LETTER REGARDING NSB KINGS BAY GA REQUESTING PERMISSION TO DISCHARGE A
GROUNDWATER STREAM TO THE CITY OF ST MARYS WASTEWATER TREATMENT
SYSTEM
1/28/1994
NSB KINGS BAY

SUBJECT: Discharge to the City of St. Marys' Point Peter Plant
Naval Submarine Base, Kings Bay, Georgia
Contract Task Order #041
Contract N62467-89-D-0317

OWN:	PROJECT NO.:	TITLE:
NLW	08503	PARTICLE TRACKING MODEL 5 YEAR SIMULATION
CHKD:	FIGURE NO.:	
KDS	5	
DATE:		
12/09/93

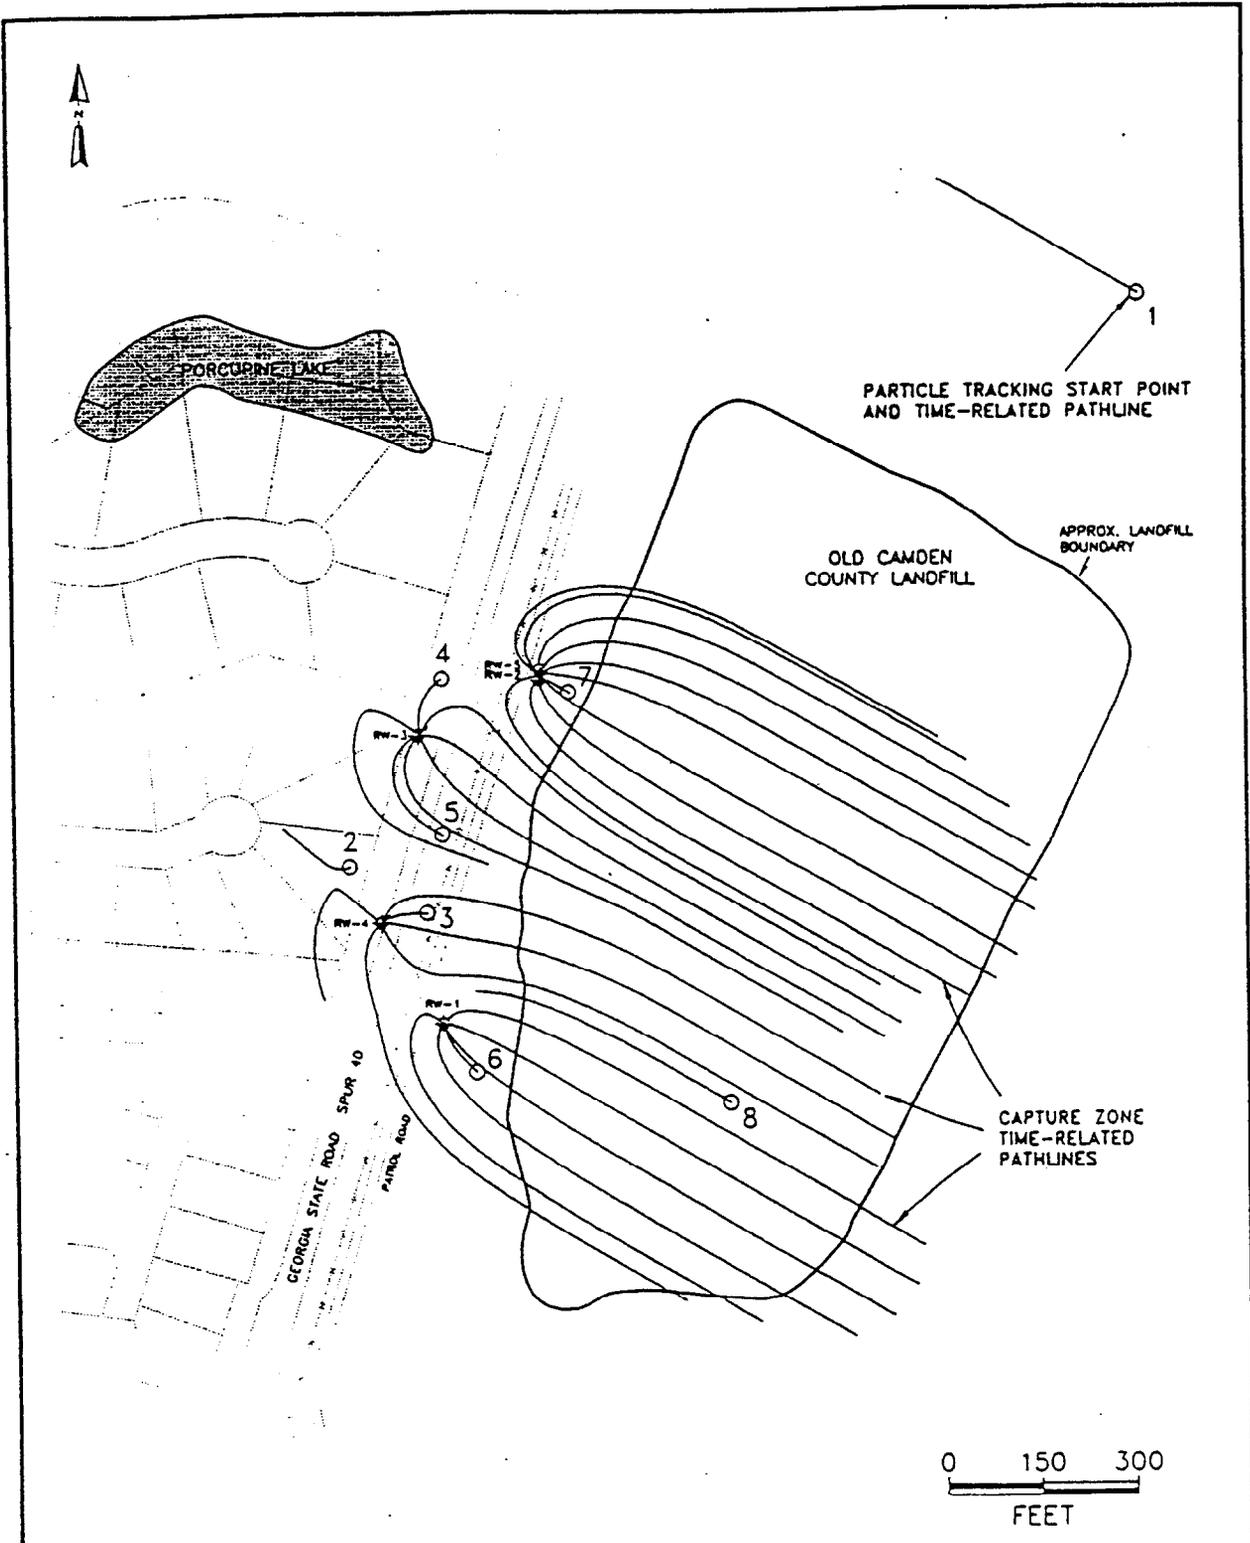
Comment 2c: Implement operating controls. During the 8 month operating period, the only proposed control is a weekly effluent sample with a one-week laboratory turn-around time. It is possible for an exceedance not to be discovered for two weeks. We recommend that some combination of on-site effluent retention and enhanced analytical frequency be implemented to allow confirmation of effluent quality prior to discharge.

Additionally, some type of rapid operational monitoring is recommended. This might consist of monitoring selected indicator parameters such as pH, specific conductivity and/or total organic carbon (TOC).

Response: During discussions between the Navy and MSE held on 5 November 1993, MSE expressed that daily monitoring of an indicator parameter (for example, TOC) would preclude the use of effluent retention. Modeling could also show that only gradual variations in groundwater chemistry or contaminant concentrations are anticipated from pumping the aquifer.

The model used to show the movement of a "slug" of contamination within or around the capture zone of the groundwater extraction wells was the two-dimensional semi-analytical General Particle Tracking Module (GPTRAC) from the USEPA's Well Head Protection Area (WHPA) delineation code. Using this model, slugs of contamination or chemical variations of the groundwater can be represented as particles transported by advective movement through the aquifer. GPTRAC models the movement of particle(s) of constituents through the proposed recovery wells' capture zones using analytical velocity computation techniques. Distance traveled therefore is time-dependent.

Several plots of the five-well recovery system and its effective capture zone are provided as Figures 1 through 5. These plots show the movement of "slugs" of constituents from seven arbitrarily selected locations within the plume. Particle #1 in each figure represents a particle within the zone unaffected by the groundwater

extraction system, or the baseline particle movement. The projected particle pathway for each model duration (7 days, 30 days, 90 days, 1 year, and 5 years) is shown to begin at the indicated circles. The pathways which appear as dots in the shorter durations are lines indicating travel distances.

The modeling shows that because of the relatively low seepage velocity within the aquifer, current groundwater quality will be representative of groundwater quality for the duration of the initial operations of the IM. Plume characteristics are expected to change slowly; however, the changes during the initial operations of the IM will be gradual enough for weekly monitoring to be sufficient to detect and respond to the changes. Vinyl chloride will be the greatest indicator of change in plume characteristics since it is a degradation product for most of the chlorinated organics present in the aquifer.
